Stormwater Review of

Example Regulated Project

Jill Bicknell, P.E.
EOA, Inc.

New Development Workshop
May 22, 2013

Stormwater Treatment Plan

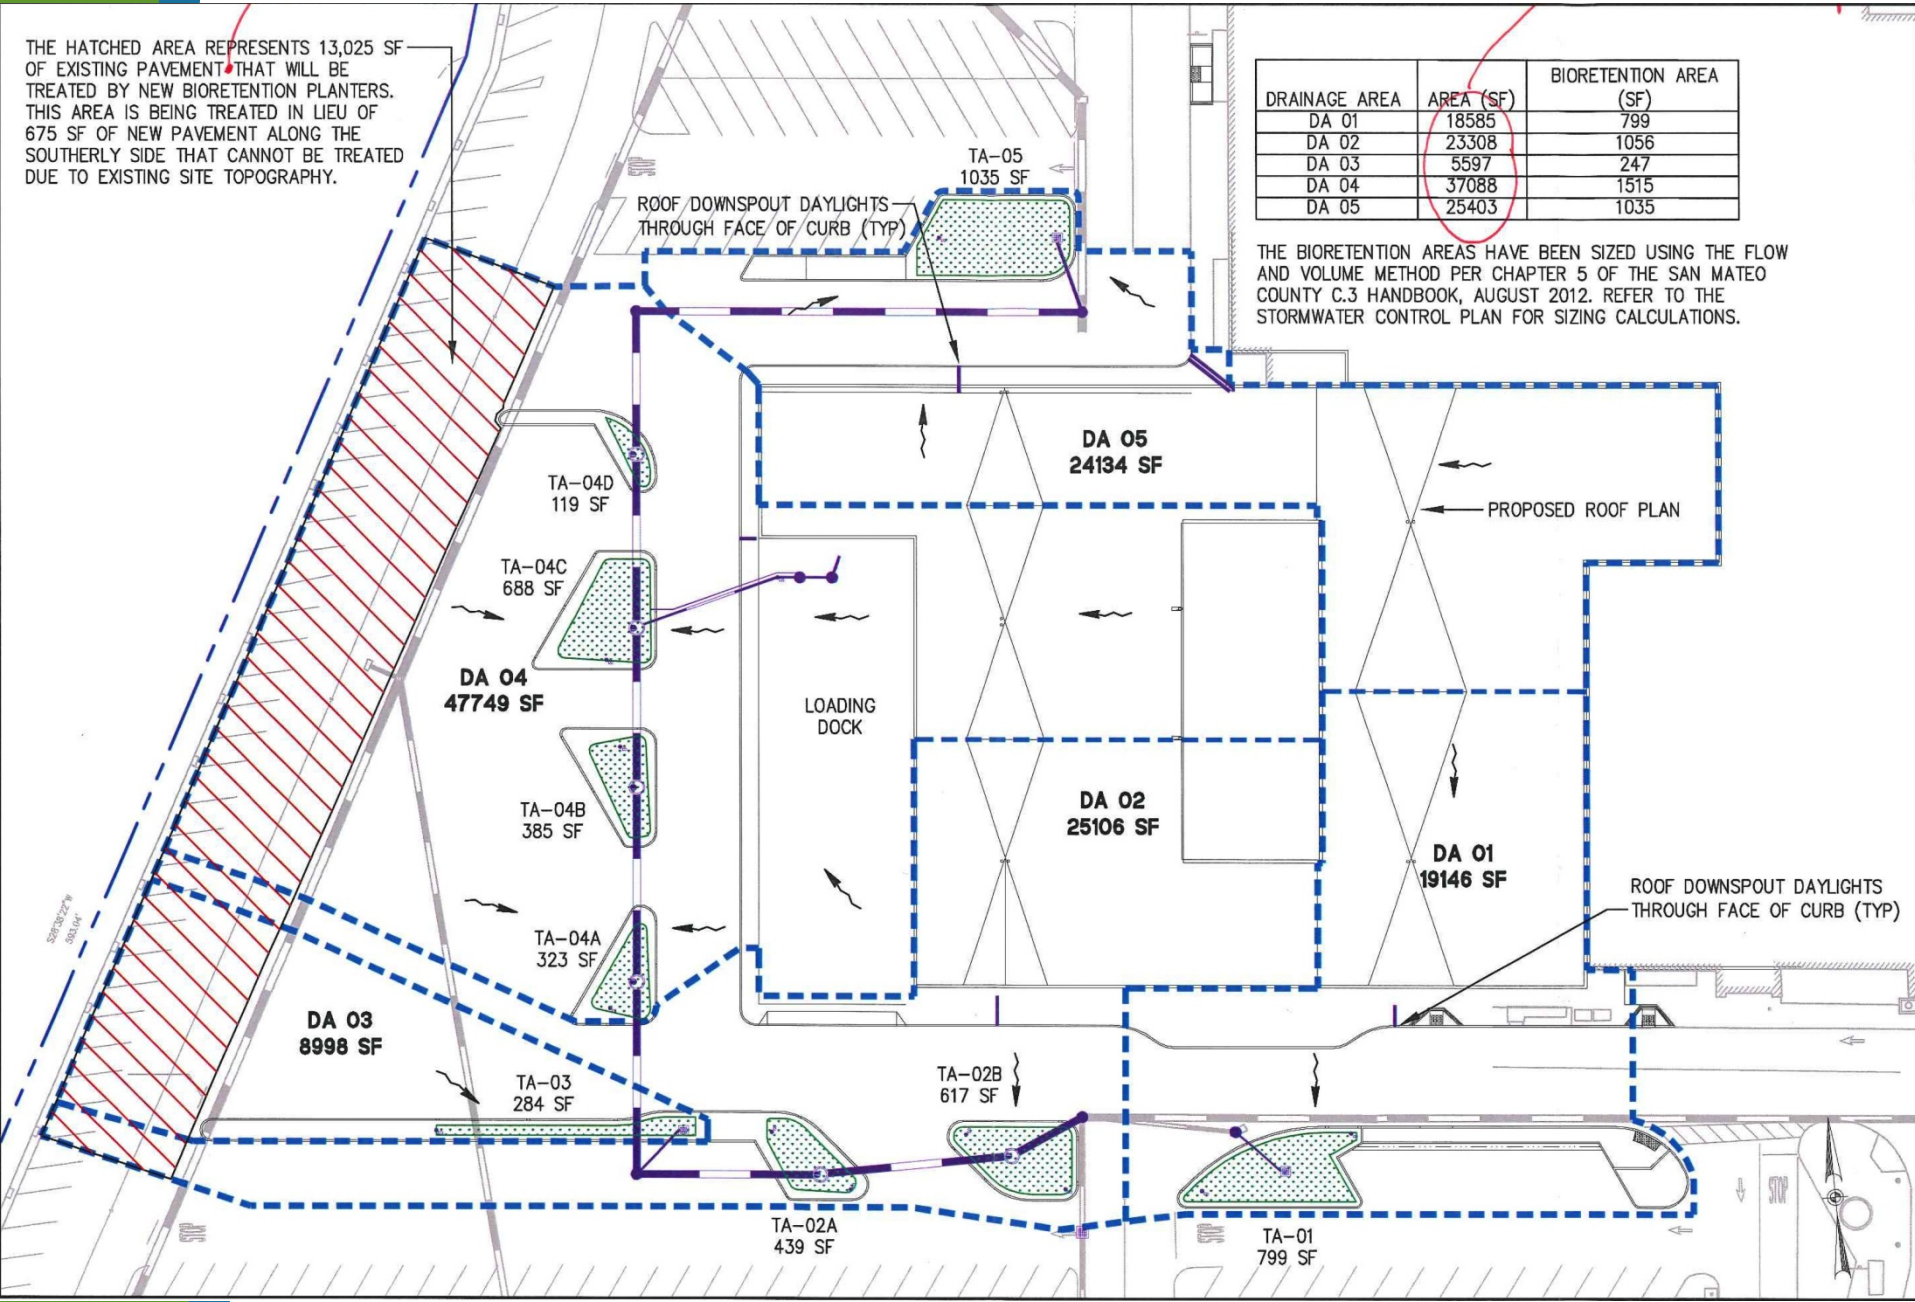
- Engineer did not delineate the drainage management area and provide sizing calculations for each treatment measure
 - Grouped 4 bioretention areas into 1 DMA
- Engineer did not account for drainage from existing parking lot into treatment measures along southern project limit
 - Added AC swale to collect runoff from existing lot and direct to storm drain inlet
 - Needed to provide “in-lieu” treatment for the swale area
